State of California
AIR RESOURCES BOARD

FINAL STATEMENT OF REASONS

**AMENDMENTS TO THE LEV III CRITERIA POLLUTANT
REQUIREMENTS FOR LIGHT- AND MEDIUM-DUTY VEHICLES, THE
HYBRID ELECTRIC VEHICLE TEST PROCEDURES, AND THE HEAVY-
DUTY OTTO-CYCLE AND HEAVY-DUTY DIESEL TEST PROCEDURES**

**Final Statement of Reasons for Rulemaking,
Including Summary of Comments and Agency Response**

Figure 4

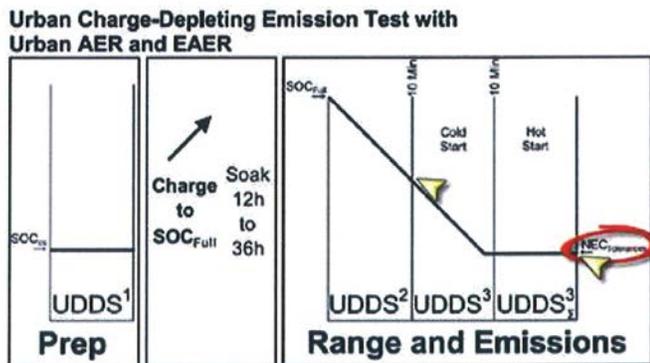
165. Comment: G.5.4.2.17 (page A-57) Primary EOT Criterion. We believe the definition of Initial and Final Amp-hour in the text is a mistake, because it conflicts with p. A-50 paragraph 8, p. A-52 5.2.8, and p. A-73 Figure 4. Paragraph 5.4.2.17 lists the primary EOT criterion as $\leq 1\%$ NEC from the beginning of the first cycle to the end of the second cycle. However, this ignores any additional hot-start cycles driven after the first 2 cycles and cannot possibly be satisfied for a charge-depleting test. Paragraph G.5.4.3.1 lists additional EOT criterion as SAE J1711 section 3.9 with permission of Executive Officer. SAE J1711 section 3.9 is the same as paragraph G.5.4.2.17 but considers the NEC over the last cycle or set of cycles, not the first 2 cycles. This additional EOT criterion (not the primary criterion) is what is shown in Figure 4. We recommend changing the paragraph G.5.4.2.17 definition of beginning and end SOC to match SAE J1711 section 3.9. Since this is primary EOT criterion, it does not require permission of Executive Officer. Then the Additional EOT criteria (which need permission) can be 1) SAE J1711 3.9.1, and 2) Final SOC > Initial SOC. (Steven Douglas, Senior Director, Environmental Affairs,

This start and end point is a carryover from HEV testing and cannot possibly be fulfilled in a charge-depleting test unless the engine turns on immediately at the beginning of the first cycle.

As shown by the two arrows indicating initial and final Amp-hr, even the example test shown in Section I Figure 4 does not fulfill this primary criterion. Additionally, the end point being identified as "NEC_{Tolerances}", as opposed to "NEC_{options}", indicates that no additional end-of-test criteria may be used to validate this test.

FIGURE 4 - SEVERAL SCENARIOS OF EOT CRITERION

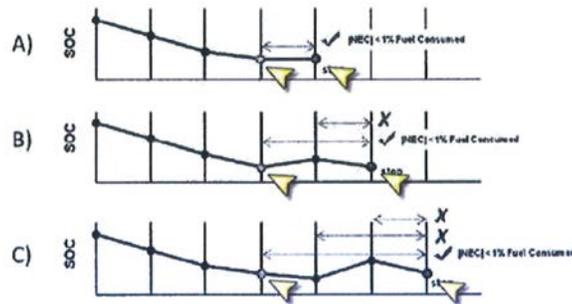
Given that this test allows more than two cycles, the primary end-of-test criterion also ignores any cycles driven after the first two.

We propose that the primary end-of-test criterion be changed to apply over the last cycle or set of cycles, as described in p. A-50 paragraph 8 for compliance and in-use testing. This also follows the spirit of the end-of-test criteria described for charge-depleting tests in SAE J1711 sections 3.9 and 3.9.1, shown here:
